GRANITE · FIRST CRACK · TEXT DRAFT

This PDF is a text draft from the BoM API, stamped as Revu markups.
The API read codes, tables and notes. It did not recognize drawn objects.
Boxes sit on text hits, not on fittings. You still sign.

FLYGEL A - PLAN 09, DEL 1
PLANRITNINGAR

FASTIGHETSNUMMER	NUMMER	BET
0001	A-40-1-1091

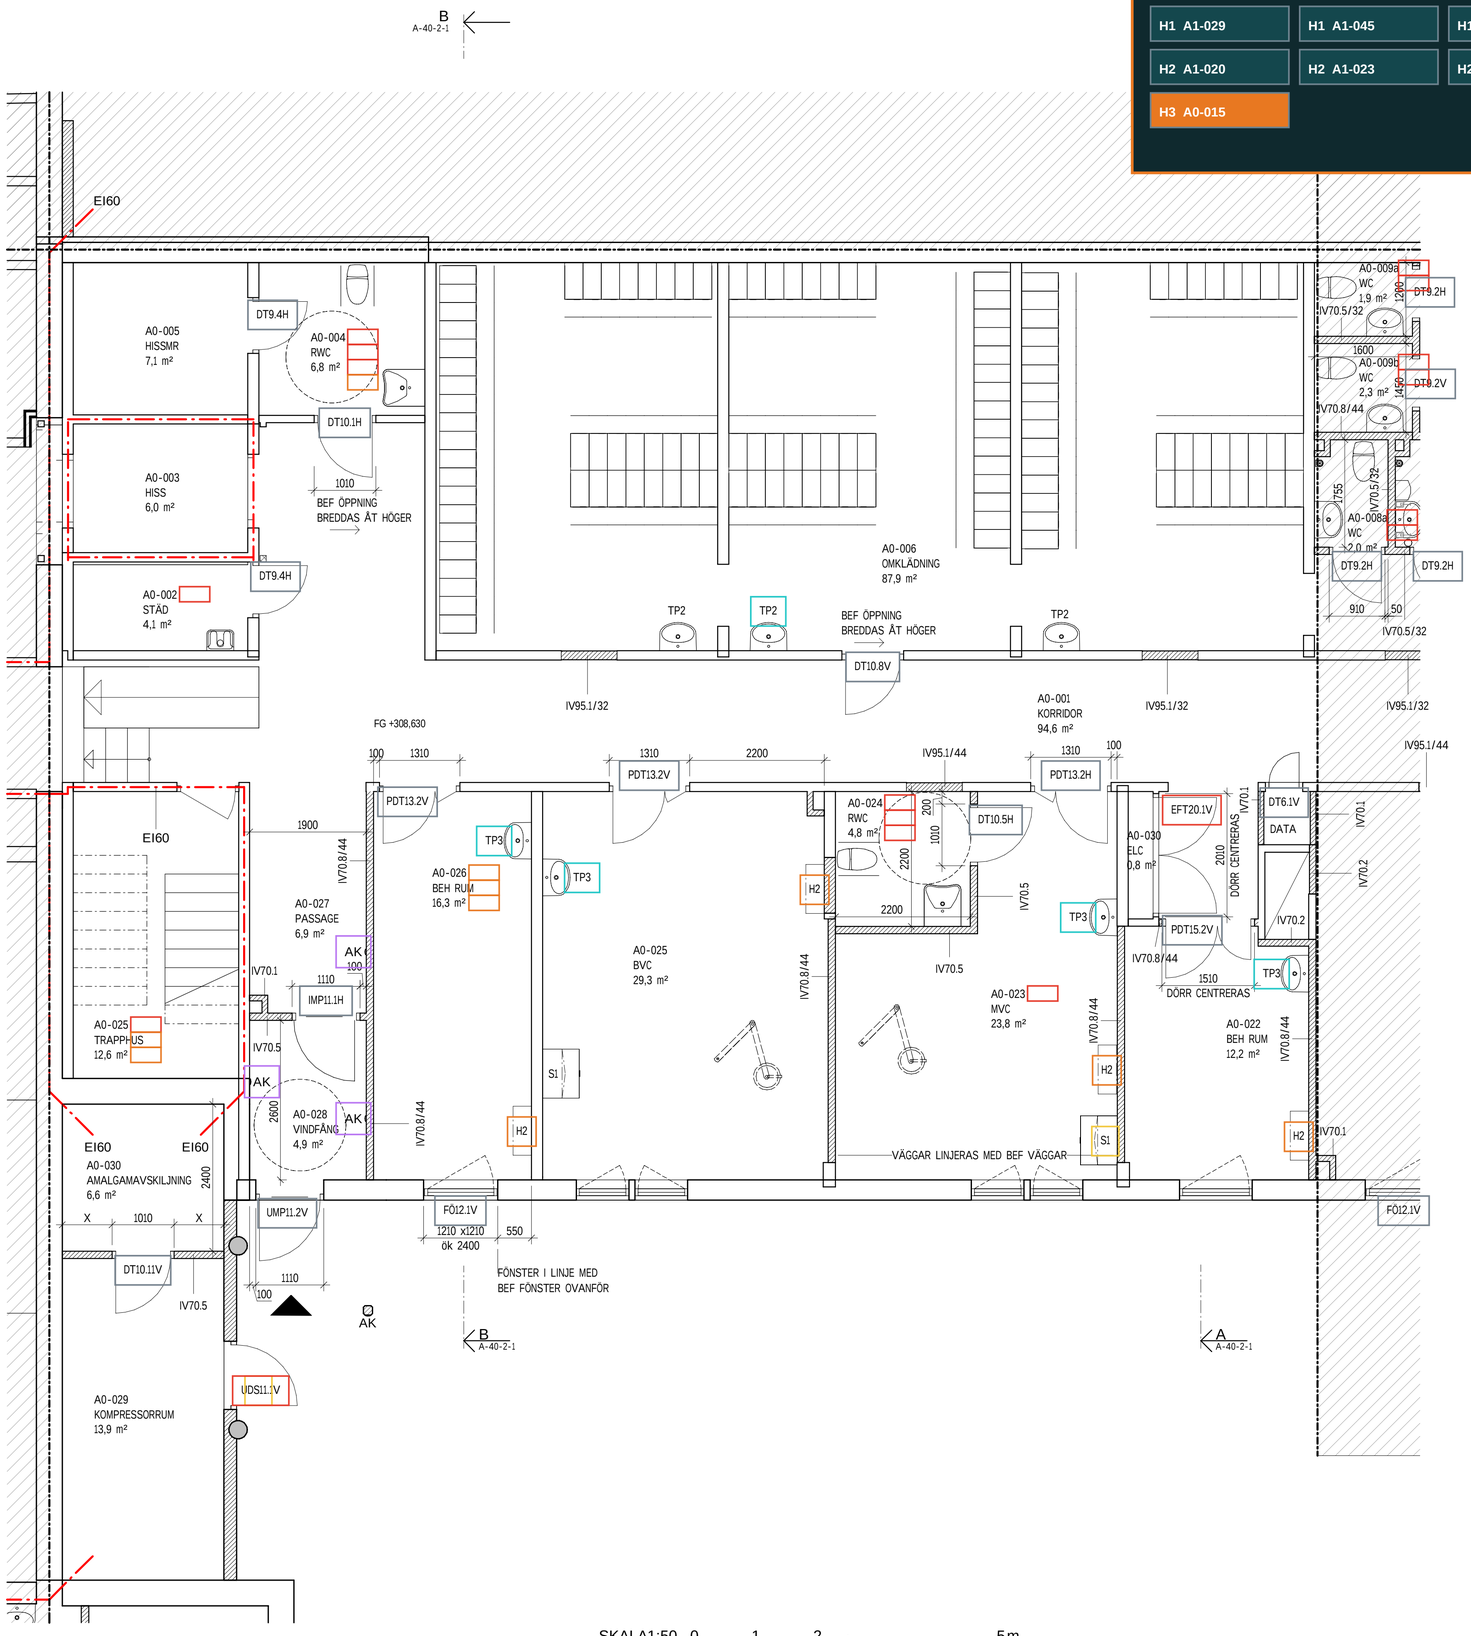
A-40-1-1091 · PLAN 09 · 81 markups in the list
Page 3 is a glance of the same list if you open this PDF without Revu.
NEED = missing info. CHECK = a note. Off-sheet shelves keep H1 / H2 / H3.

NOT ON THIS SHEET · request only · H3 is here · room A0-015 is not on PLAN 09

Subject	Flag	Qty	Room	Comment	What is missing / note
EFT20.1V	NEED	1	A0-030	EFT20.1V, ELC; description unavailable	The draft has a mark but no product type. Do not invent an article.
H2	NEED	1	A0-022	Hylla H2; length and specification unavailable	The floor plan marks the shelf. Length and spec are on the room description · that file
H2	NEED	1	A0-023	Hylla H2; length and specification unavailable	The floor plan marks the shelf. Length and spec are on the room description · that file
H2	NEED	1	A0-025	Hylla H2; length and specification unavailable	The floor plan marks the shelf. Length and spec are on the room description · that file
H2	NEED	1	A0-026	Hylla H2; length and specification unavailable	The floor plan marks the shelf. Length and spec are on the room description · that file
NEED	NEED	1	A0-002	Utslagsback	A sanitary symbol is drawn, but there is no type code. Need the setting-out / type stand

NEED	NEED	2	A0-004	Stödarm	A sanitary symbol is drawn, but there is no type code. Need the setting-out / type stand
NEED	NEED	1	A0-004	Tvättställ	A sanitary symbol is drawn, but there is no type code. Need the setting-out / type stand
NEED	NEED	1	A0-004	WC-stol	A sanitary symbol is drawn, but there is no type code. Need the setting-out / type stand
NEED	NEED	1	A0-008a	Tvättställ	A sanitary symbol is drawn, but there is no type code. Need the setting-out / type stand
NEED	NEED	1	A0-008a	WC-stol	A sanitary symbol is drawn, but there is no type code. Need the setting-out / type stand
NEED	NEED	1	A0-009a	Tvättställ	A sanitary symbol is drawn, but there is no type code. Need the setting-out / type stand
NEED	NEED	1	A0-009a	WC-stol	A sanitary symbol is drawn, but there is no type code. Need the setting-out / type stand
NEED	NEED	1	A0-009b	Tvättställ	A sanitary symbol is drawn, but there is no type code. Need the setting-out / type stand

NEED	NEED	1	A0-009b	WC-stol	A sanitary symbol is drawn, but there is no type code. Need the setting-out / type stand
NEED	NEED	1	A0-023	Unidentified articulated arm with circular head; product type to be confirmed	The draft has a mark but no product type. Do not invent an article.
NEED	NEED	2	A0-024	Stödarm	A sanitary symbol is drawn, but there is no type code. Need the setting-out / type stand
NEED	NEED	1	A0-024	Tvättställ	A sanitary symbol is drawn, but there is no type code. Need the setting-out / type stand
NEED	NEED	1	A0-024	WC-stol	A sanitary symbol is drawn, but there is no type code. Need the setting-out / type stand
NEED	NEED	1	A0-025	Unidentified articulated arm with circular head; product type to be confirmed	The draft has a mark but no product type. Do not invent an article.
NEED	NEED	1	·	Tvättställ, partially shown east of A0-008a	A sanitary symbol is drawn, but there is no type code. Need the setting-out / type stand

NEED	NEED	1	·	WC-stol, partially shown east of A0-008a	A sanitary symbol is drawn, but there is no type code. Need the setting-out / type stand
S1	NEED	1	A0-023	S1; description unavailable	The draft has a mark but no product type. Do not invent an article.
S1	NEED	1	A0-025	S1; description unavailable	The draft has a mark but no product type. Do not invent an article.
TP2	NEED	3	A0-006	TVÄTTPLATSUTRUSTNING	This is a package code. What is inside it comes from the type standard, which is not in
TP3	NEED	1	A0-022	TVÄTTPLATSUTRUSTNING	This is a package code. What is inside it comes from the type standard, which is not in
TP3	NEED	1	A0-023	TVÄTTPLATSUTRUSTNING	This is a package code. What is inside it comes from the type standard, which is not in
TP3	NEED	1	A0-025	TVÄTTPLATSUTRUSTNING	This is a package code. What is inside it comes from the type standard, which is not in
TP3	NEED	1	A0-026	TVÄTTPLATSUTRUSTNING	This is a package code. What is inside it comes from the type standard, which is not in

UDS11.1V	NEED	1	A0-029	UDS11.1V, KOMPRESSORRUM; description unavailable	The draft has a mark but no product type. Do not invent an article.
CHECK	CHECK	·	·	10 lines have no room (hatches, match-line items, one elbow tap).	Verify before you sign.
CHECK	CHECK	·	·	17 lines have no type code (WC, basin, support arms, unidentified arms).	Verify before you sign.
CHECK	CHECK	·	·	All 69 API lines are in this draft. The six recovered lines are other-floor request shelves,	Noted.
CHECK	CHECK	·	·	Doors, windows and metal frames are in the draft but kept out of the customer basket (other	Noted.
CHECK	CHECK	·	·	H2 is drawn, but length is not on this floor plan.	Verify before you sign.
CHECK	CHECK	·	·	Hatch quantities come from a table on the sheet, not from counting rooms.	Verify before you sign.
CHECK	CHECK	·	·	Only this PDF was uploaded. Ten other drawings, the room description and the type standard a	Verify before you sign.

CHECK	CHECK	·	·	Request-only shelves stay out of this basket: 4× H1, 8× H2, 1× H3 (A0-015). They stay on the	Noted.
CHECK	CHECK	·	·	S1, EFT20.1V, UDS11.1V and two articulated arms have no product type.	Verify before you sign.
CHECK	CHECK	·	·	TP3 / TP2 are package codes. Contents need the type standard.	Verify before you sign.
CHECK	CHECK	·	·	The customer asked for H2. The old specialist quote never listed H2.	Verify before you sign.
CHECK	CHECK	·	·	The four H2 rooms in the email are on this plan (A0-022, 023, 025, 026).	Noted.
AK	On sheet	1	A0-027	ARMBÅGSKONTAKT	Elbow tap is drawn. Confirm article and whether it belongs in this fittings quote.
AK	On sheet	2	A0-028	ARMBÅGSKONTAKT	Elbow tap is drawn. Confirm article and whether it belongs in this fittings quote.
AK	On sheet	1	·	ARMBÅGSKONTAKT outside entrance	Elbow tap is drawn. Confirm article and whether it belongs in this fittings quote.
IL.4	On sheet	2	·	HILA Inspektionslucka 300x300 mm	From the hatch table on this sheet, not counted on the floor.
